# University of Kentucky<sup>®</sup>

CCK-2564.0-9-24

Construct Health Education Building

ADDENDUM #3

**TYPICAL FOUNDATION DETAILS**  
**S-301**  
COPYRIGHT 2024 - JRA, INC.

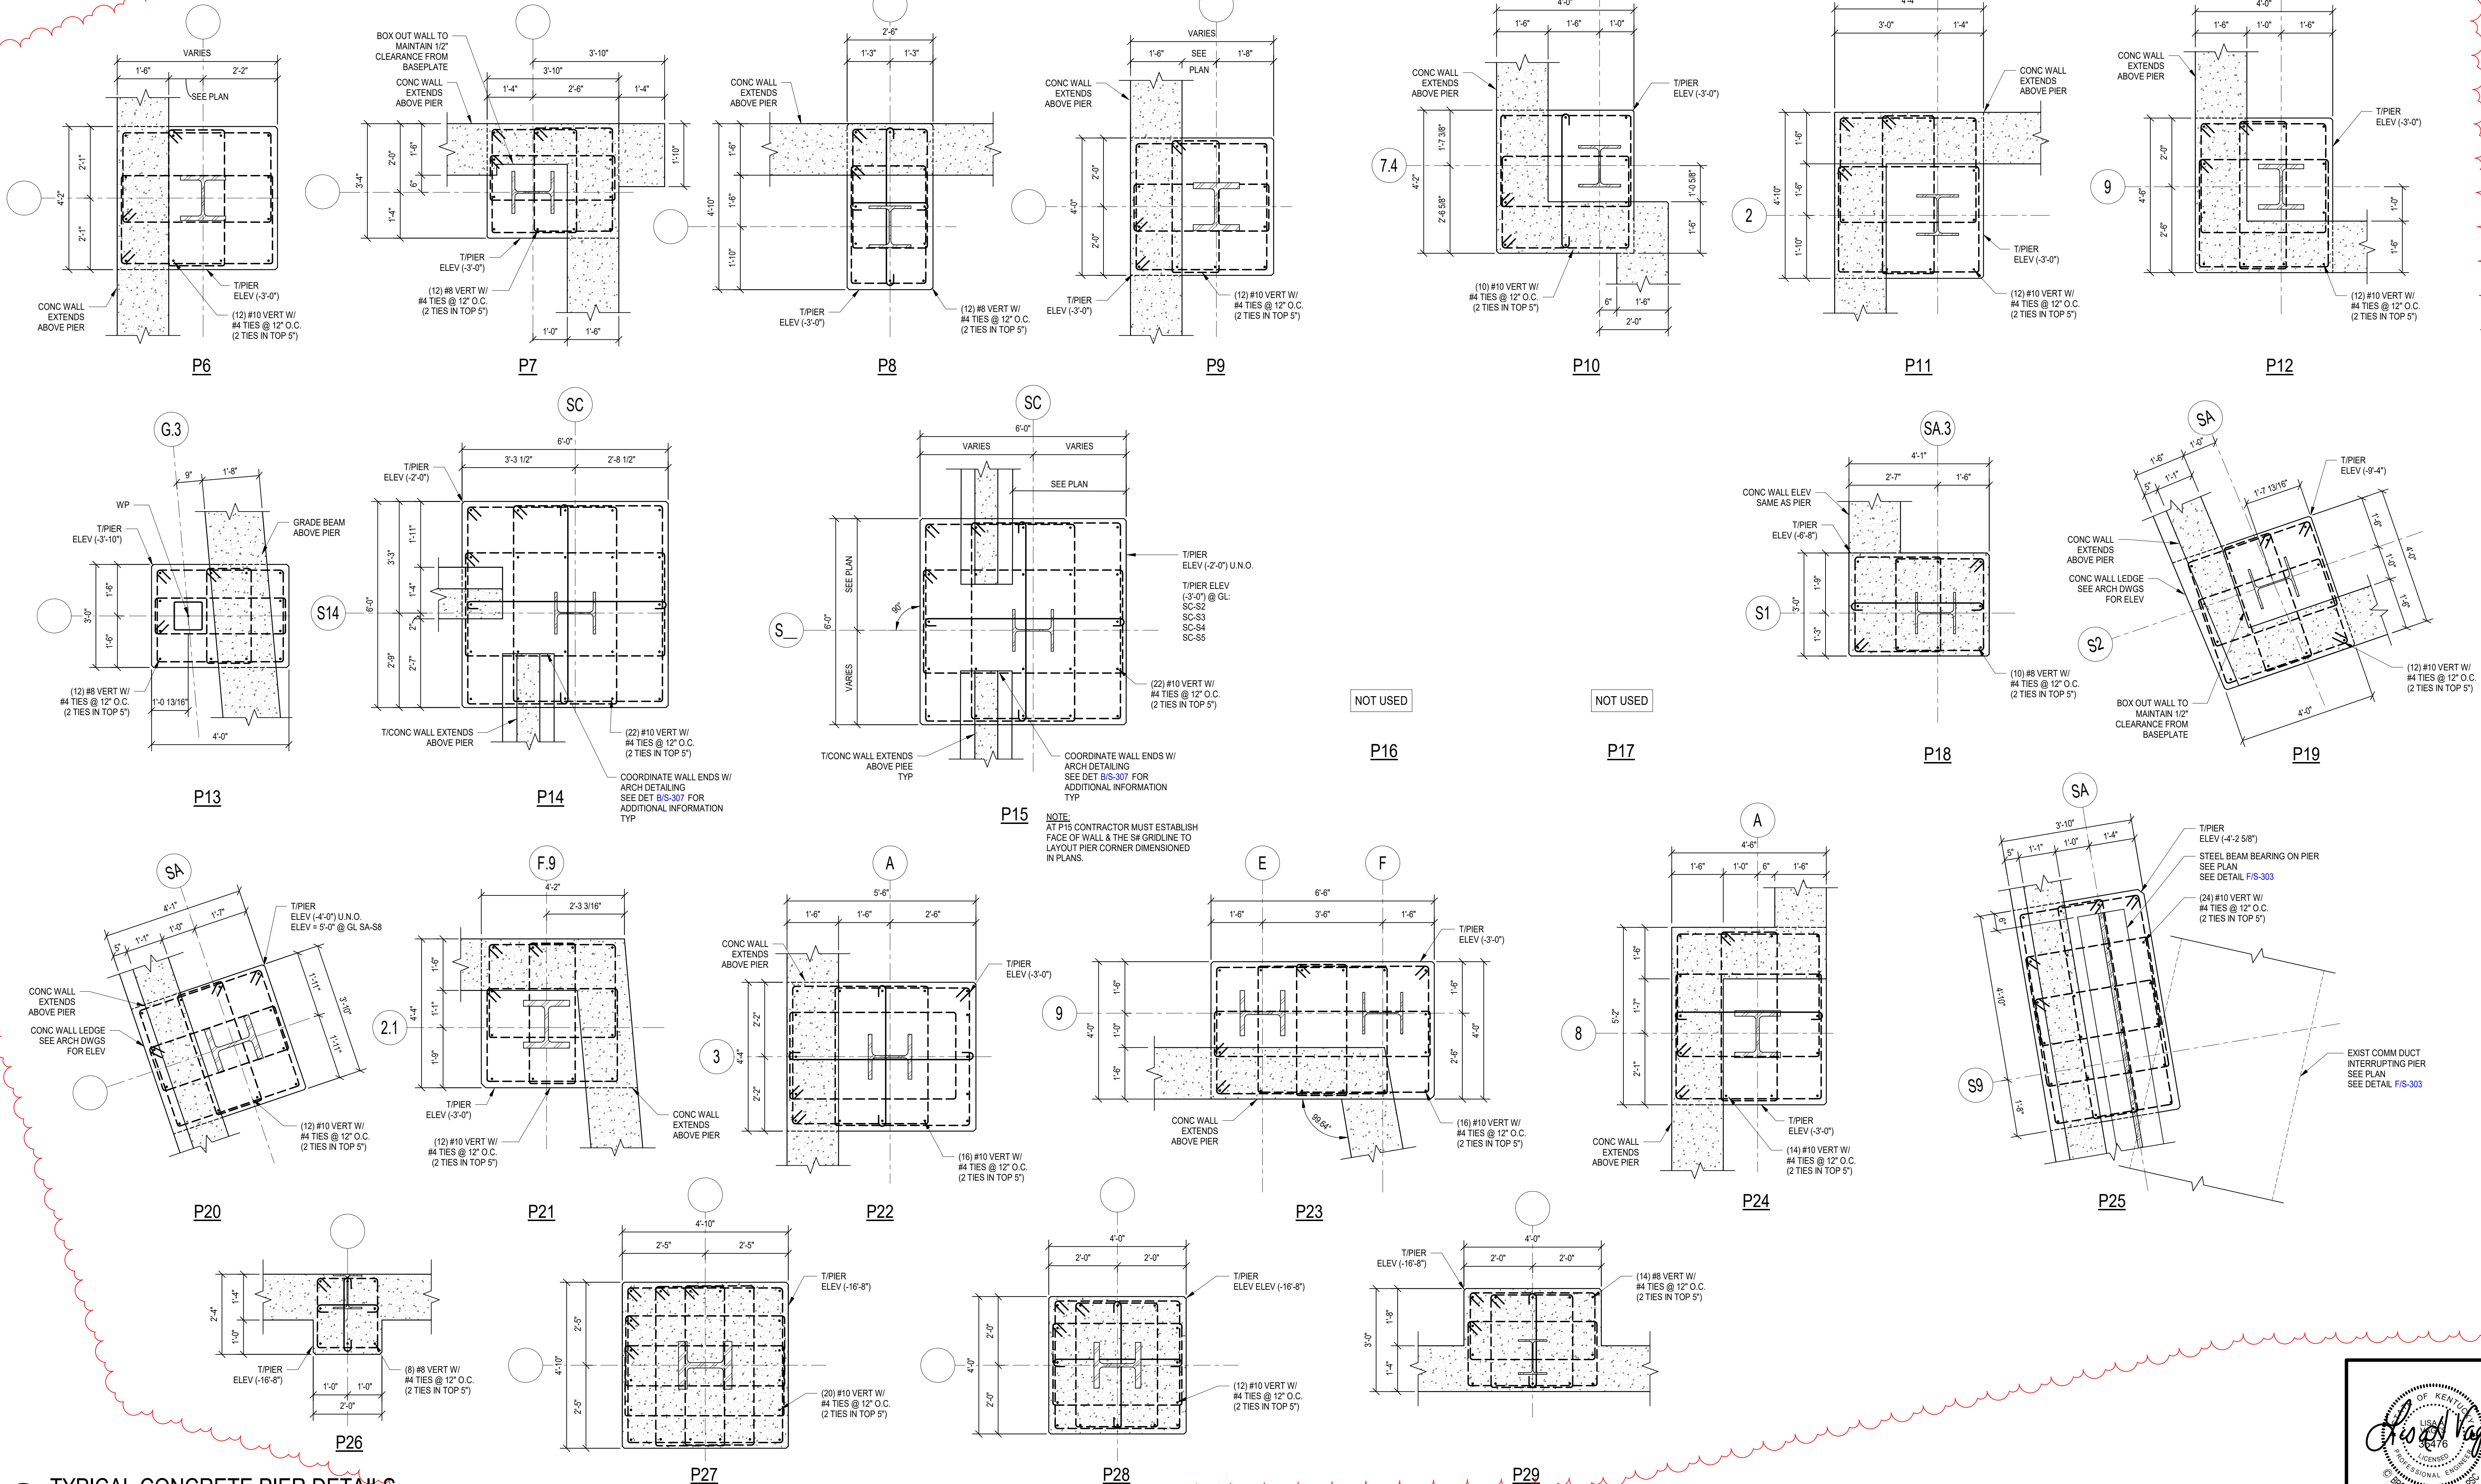
Refer to attached sheet S-301. Deleted unused footing marks from schedule, updated reinforcement noted in schedule.

**TYPICAL FOUNDATION DETAILS**  
**S-302**  
COPYRIGHT 2024 - JRA, INC.

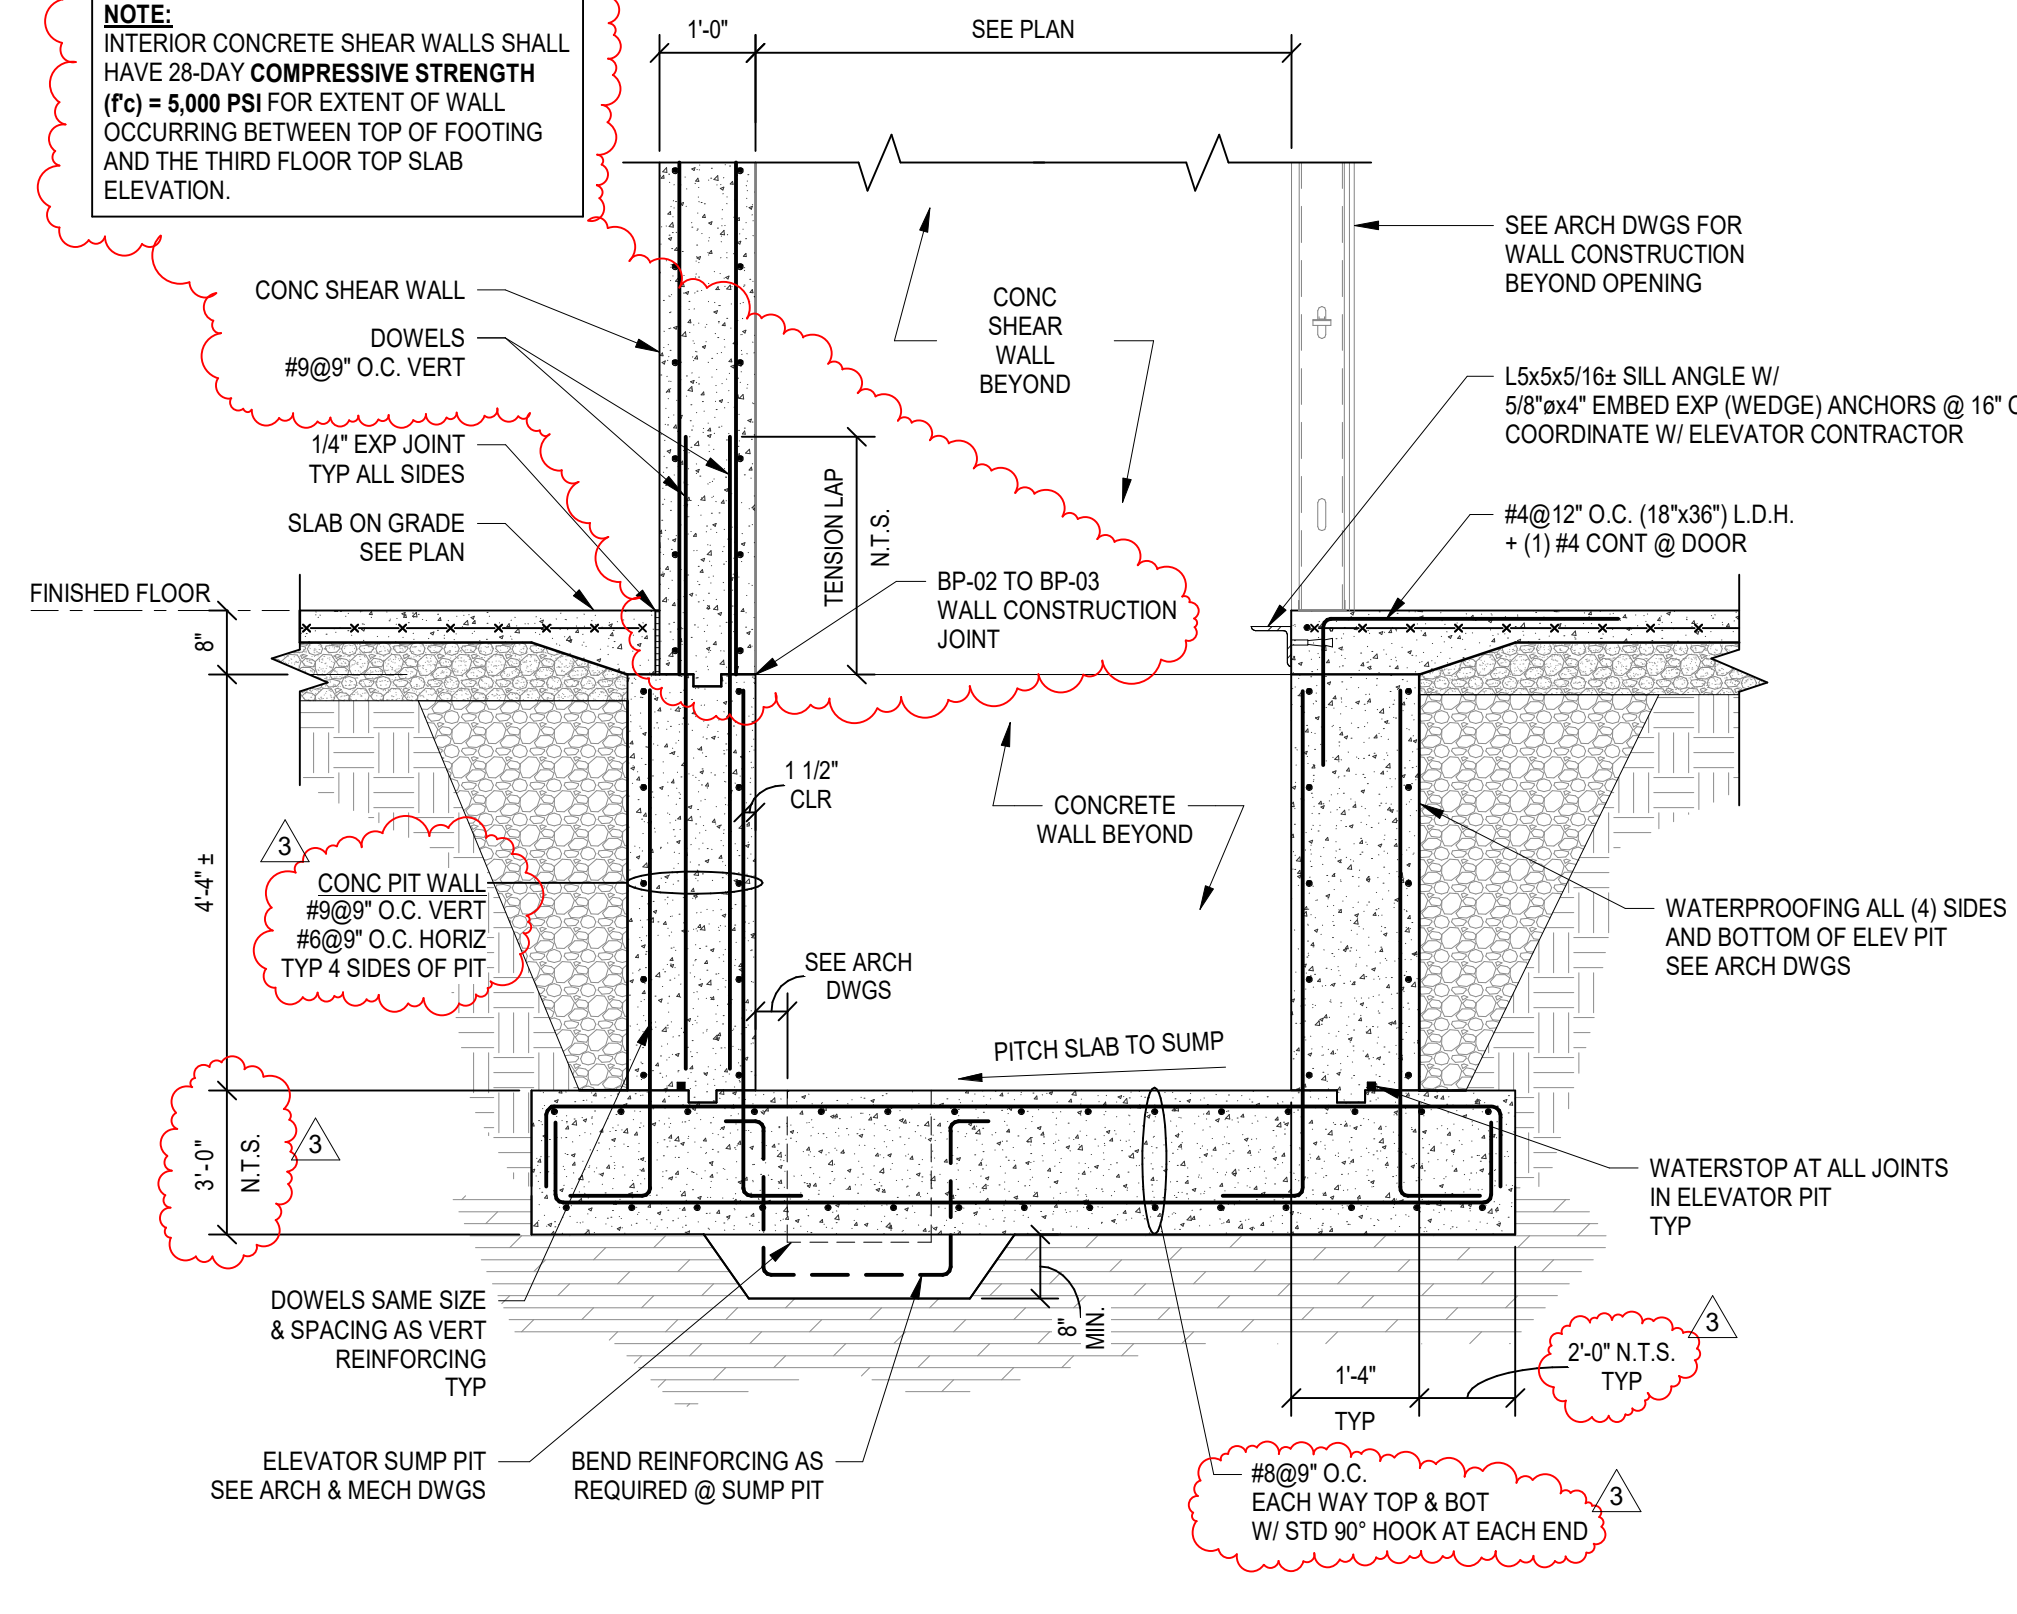
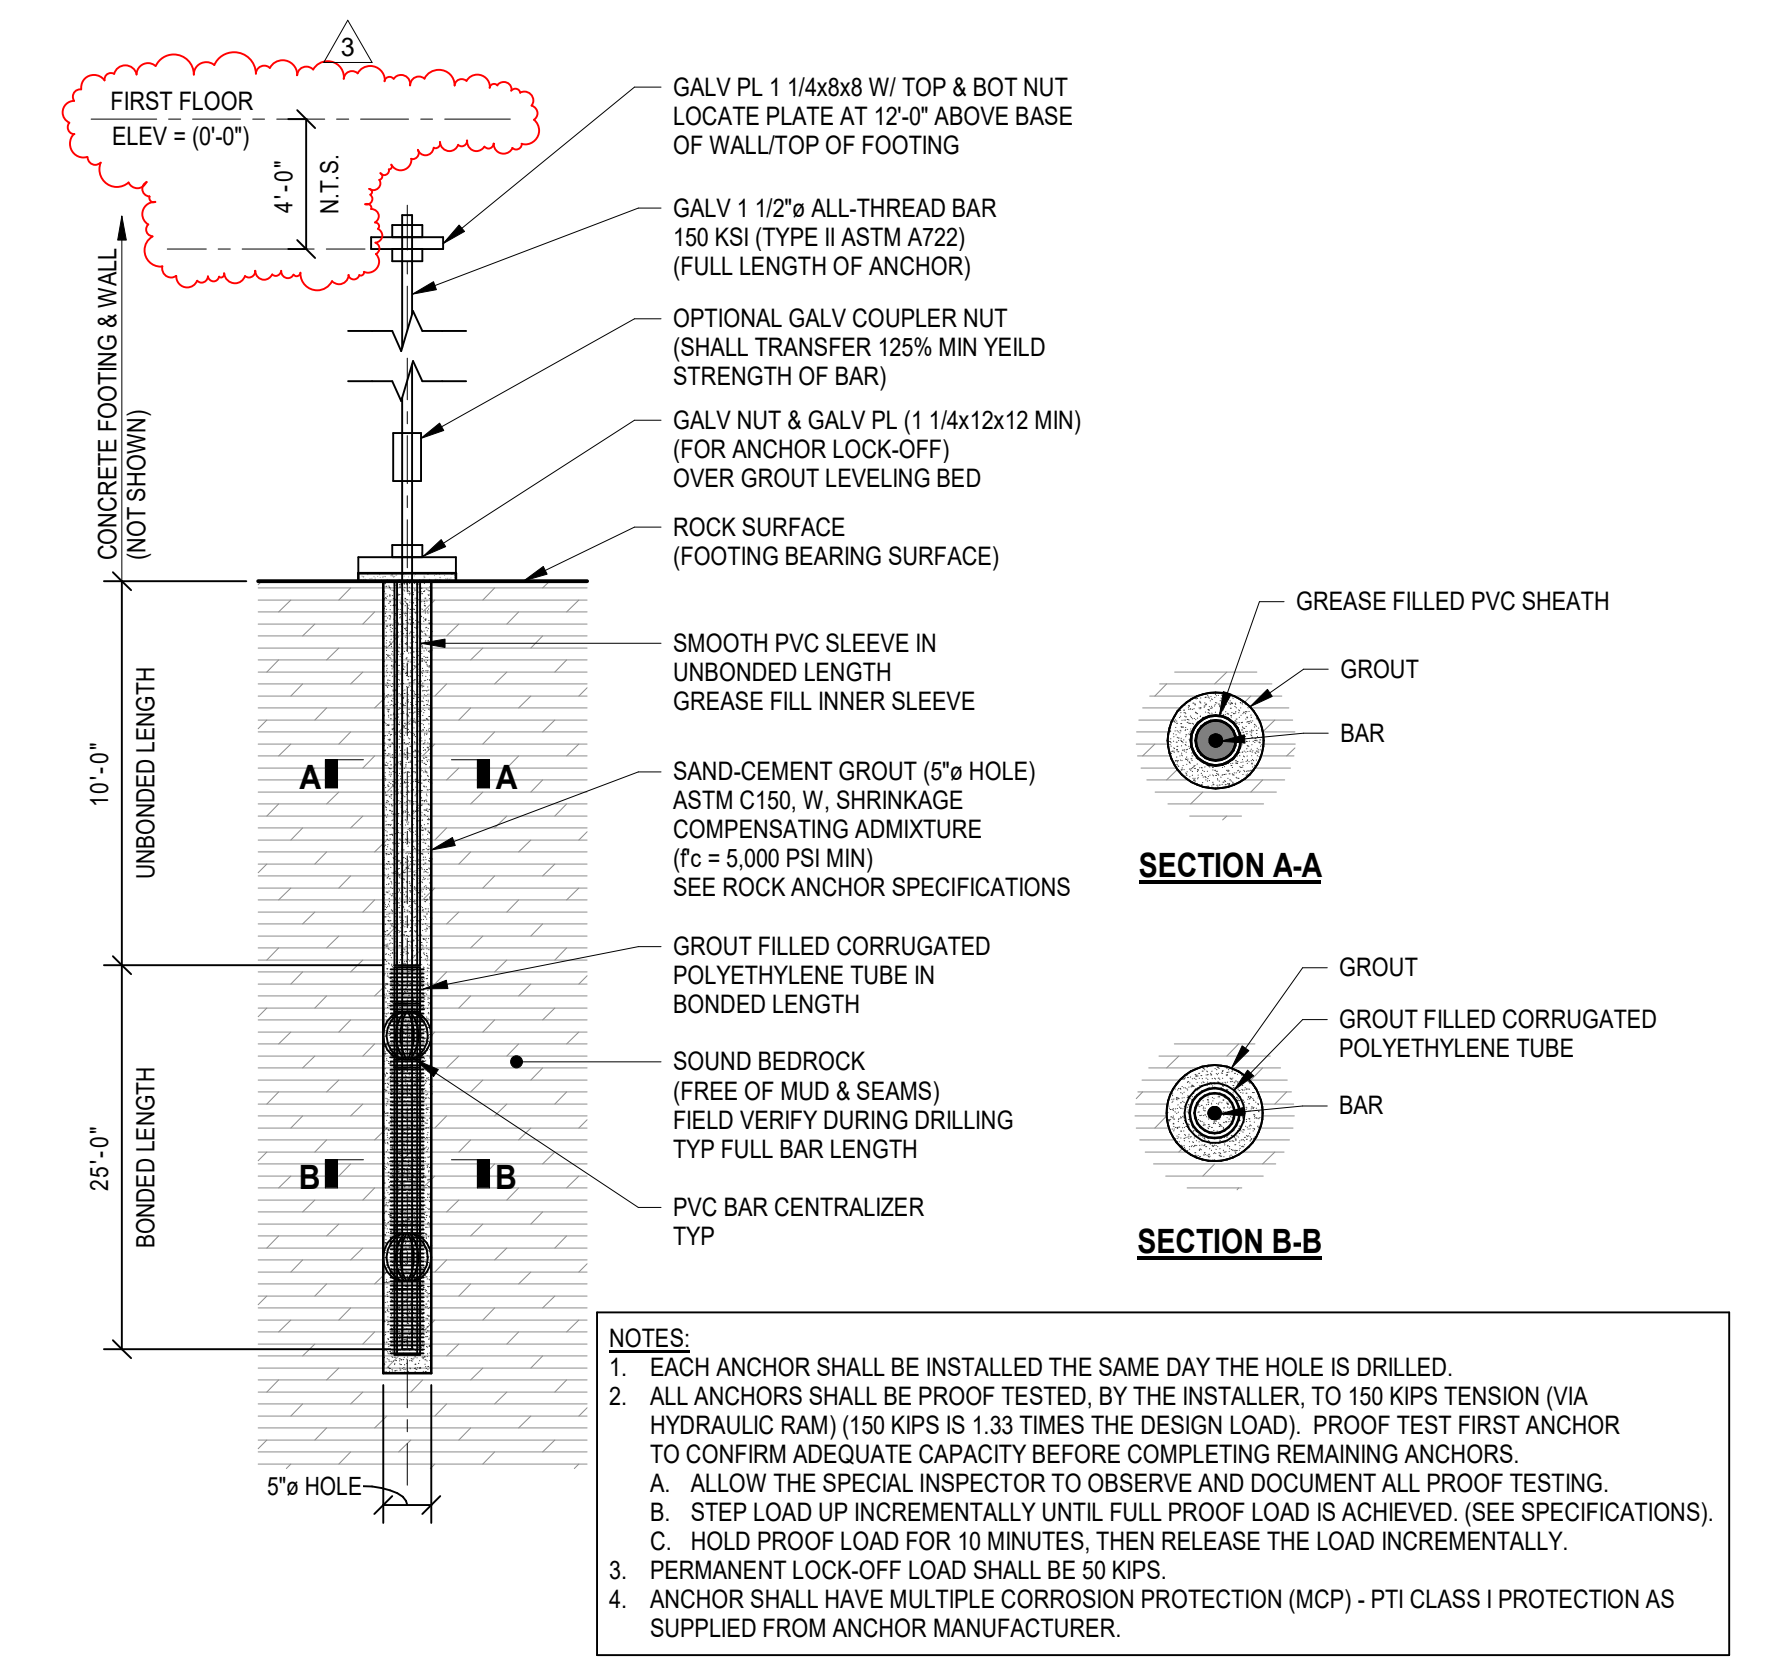
Refer to attached sheet S-302. Updated pier sizes and reinforcement. Added additional pier types.
